**CHARTER TOWNSHIP OF VAN BUREN
PLANNING COMMISSION AGENDA
Wednesday, January 23, 2019 – 7:30 PM, Board of Trustees Room**

**Subject: VBT-18-035; Costco Dry Depot Addition; 5860 Belleville Road; Final Site Plan Review #2
Revised Site Plans Dated December 17, 2018.**

Re: Costco Dry Depot Addition
5860 Belleville Road
Engineering Plan Review and Final Site Plan Review

**Subject: VBT-18-036; U.S Signals Data Center; 9275 Haggerty Road; Preliminary Site Plan Review #2
Revised Site Plans Dated November 30, 2018; Recd. by Township 1/2/2019.**

14'-0" HIGH GRAVITY WALL DETAIL
NOT TO SCALE

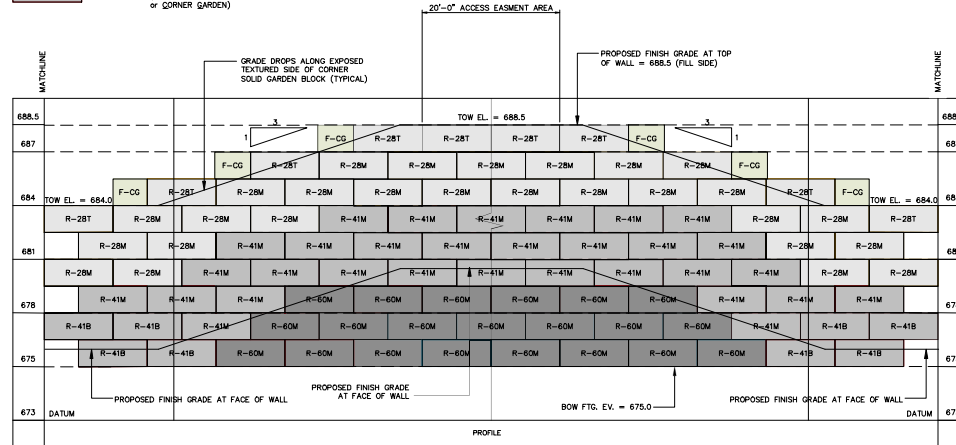
In addition to the VVRC, site security includes perimeter fencing that consists of an 8'H anti-climb/K-rated barrier fence (entire site perimeter), and 8'H precast concrete block wall along the western and northern boundaries. Additionally, along the entrance driveway to the VVRC, a 14'H decorative precast concrete block wall is proposed to provide a protective 'screen' from the main building of any potential threat that enters the site. This wall and 3' horizontal to 1' vertical earth berm currently exceeds the permitted wall height by six feet. Therefore, JPMC is requesting a variance as follows:

The proposed VVRC building has a parapet height of 24'-0" from the ground which is immediately adjacent to the proposed 14'-0" high screen wall (within 10LF). The wall is to be constructed from large decorative colored weathered limestone with a textured finish (refer to enclosed REDI-ROCK KINGSTONE sample sheet). Each precast concrete block (face) measures approximately 18"Hx45"L and will be installed approximately 10-feet west of the new VVRC building, extending north along the west side of the proposed entrance drive approximately 685-feet north with 90 degree wing walls at each end. The face of wall shall be approximately 275-feet from the Haggerty Road property line, and 200-feet from the Haggerty Road building setback. The size and scale of the proposed wall shall be diminished by the distance from the public thoroughfare (Haggerty Road) and adjacent VVRC building.
